Addendum No. 1

Re: Part B - James M. Seals, JR. Park – Athletic Restroom/ Concession and Field Improvements
504 Texas Street, Mobile, AL 36603
Project No. PR-041-20
Part C - Hackmeyer Park – Improvements Phase 2
3810 Conway Drive South, Mobile, AL 36608
Project No. PR-034-21

Date: November 14, 2022

A1.1
 RESTROOM/
 CONCESSION
 BUILDING -
 FLOOR PLAN

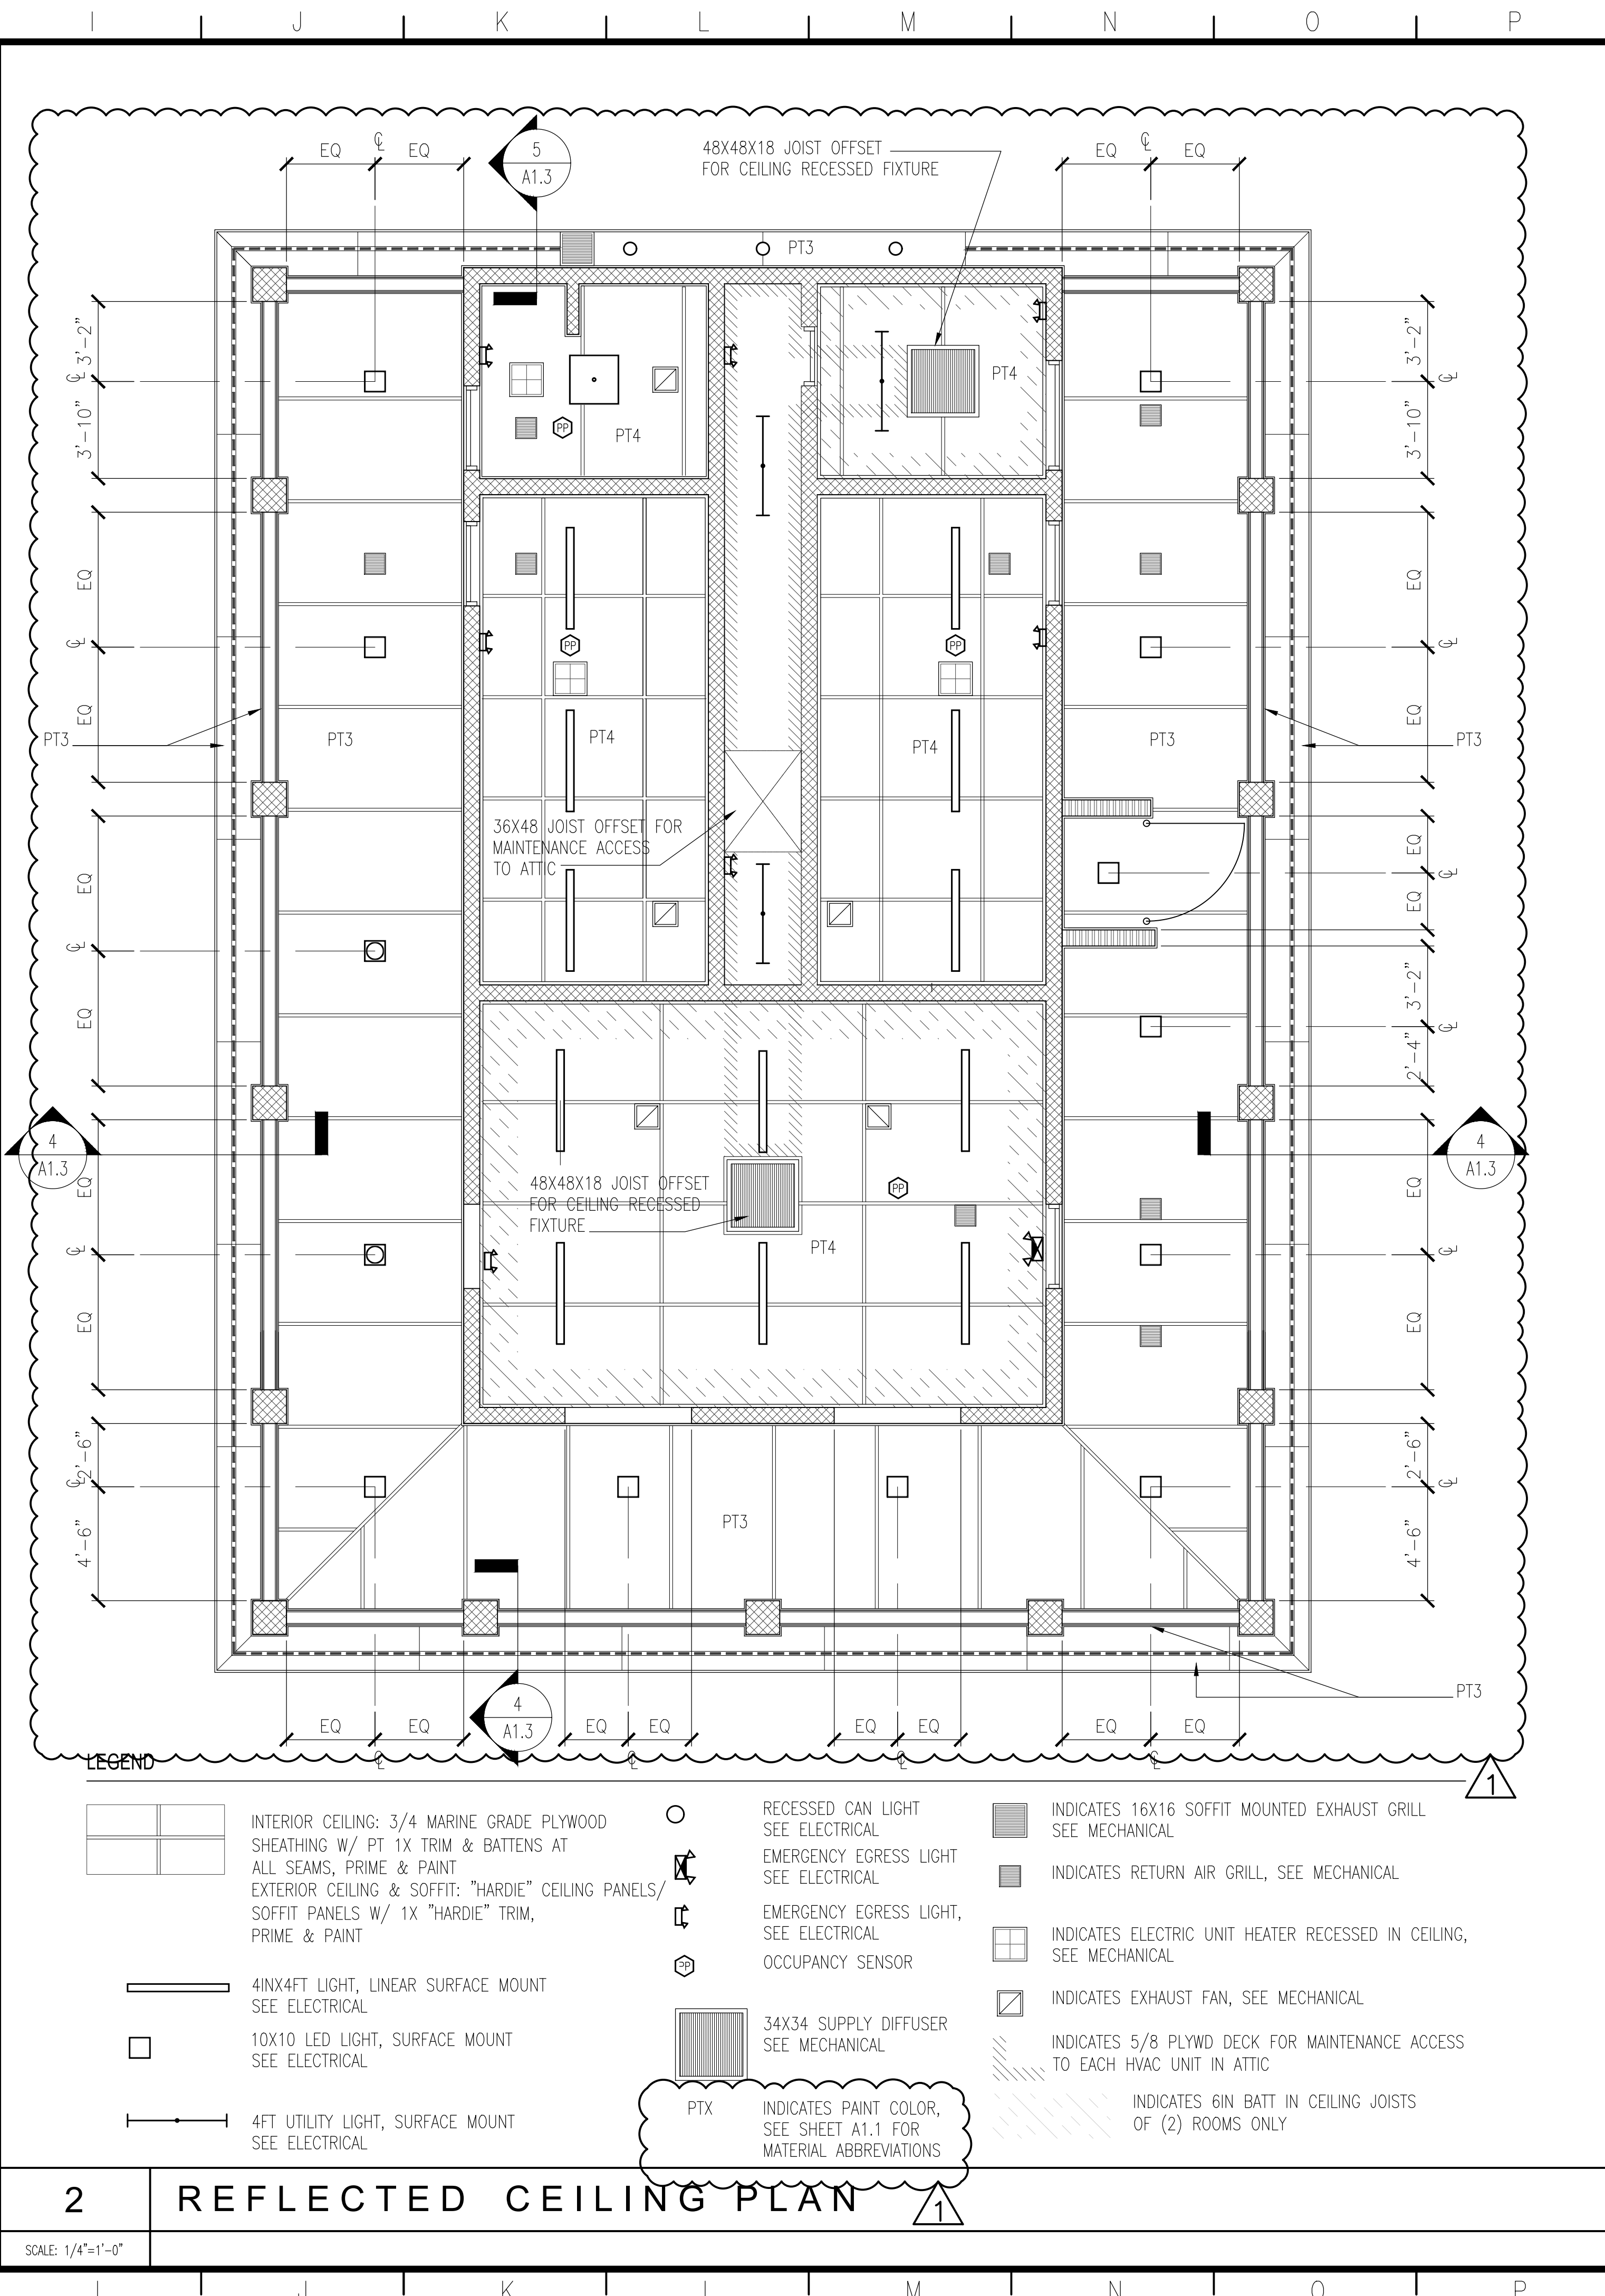
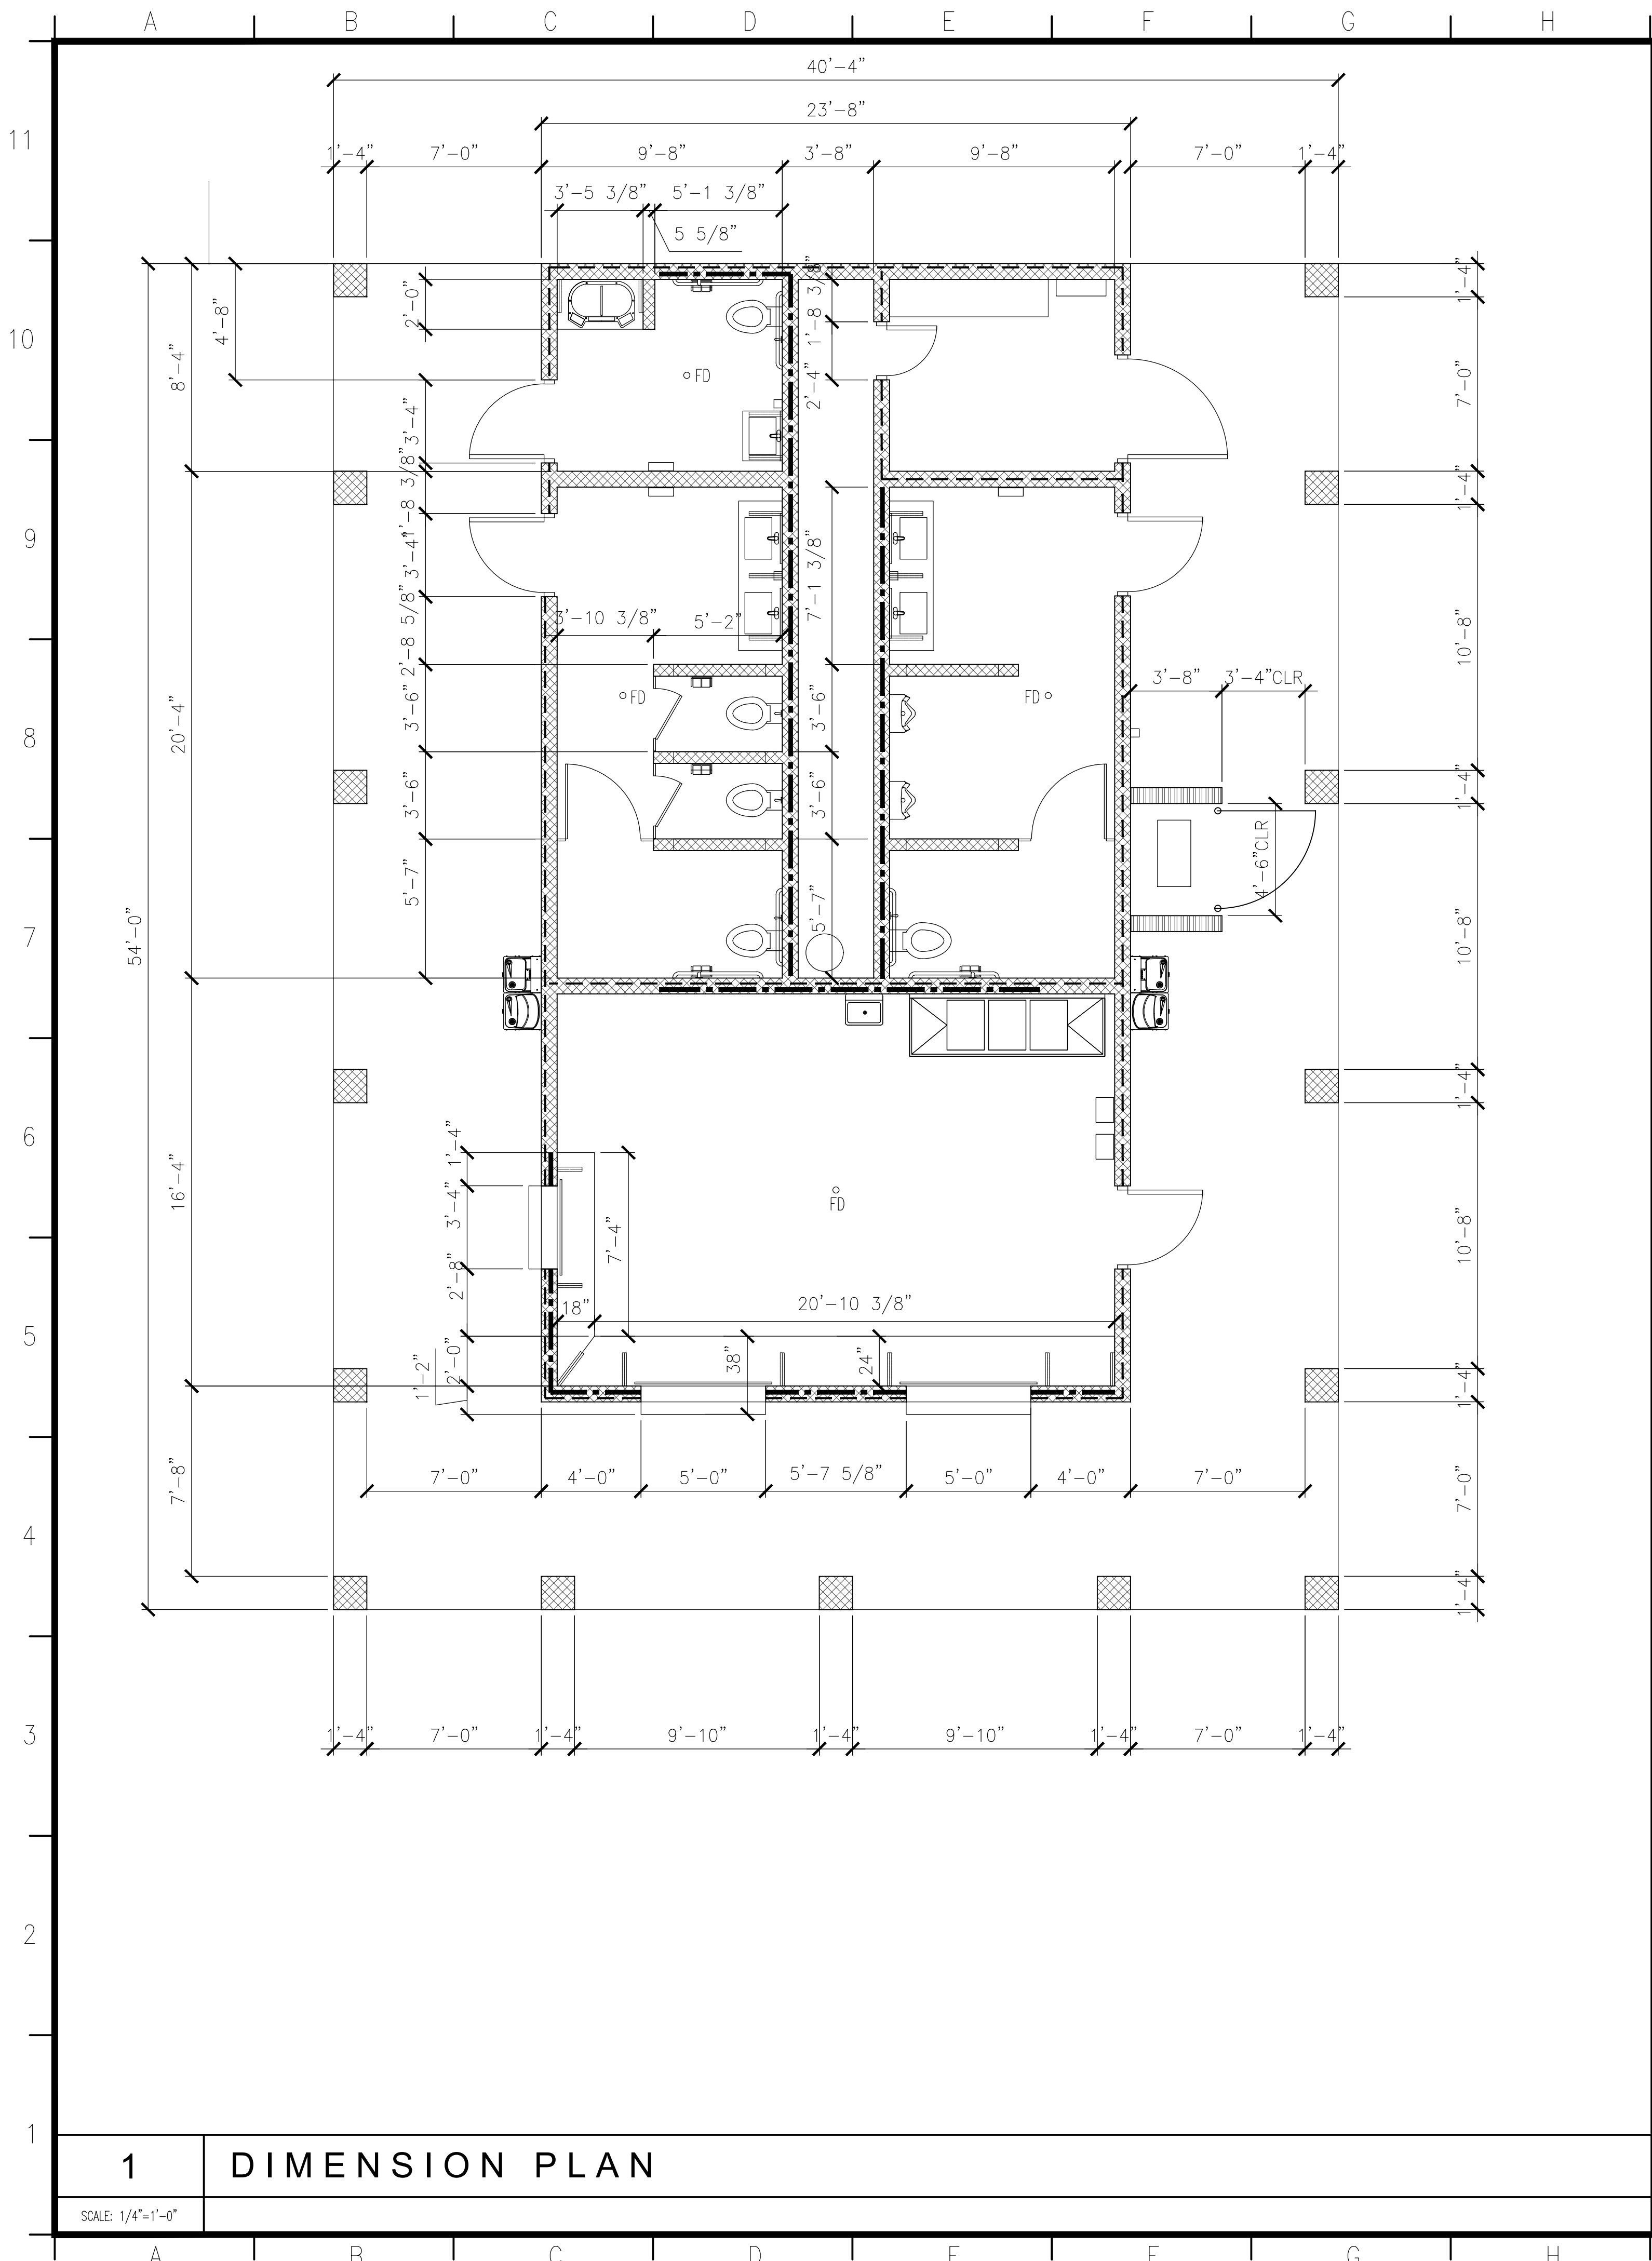
Item 13: Sheet A1.1 Building – Dimension & Reflected Ceiling Plans

Replace this sheet dated 11.02.22 with the attached revised sheet of same title A1.1, dated November 07, 2022 and labeled Revision 01 (Addendum No. 1). Substantial changes include the following:

- Add keynote for Knox Box model & installation location.
- Update hose bibb locations to match plumbing design.
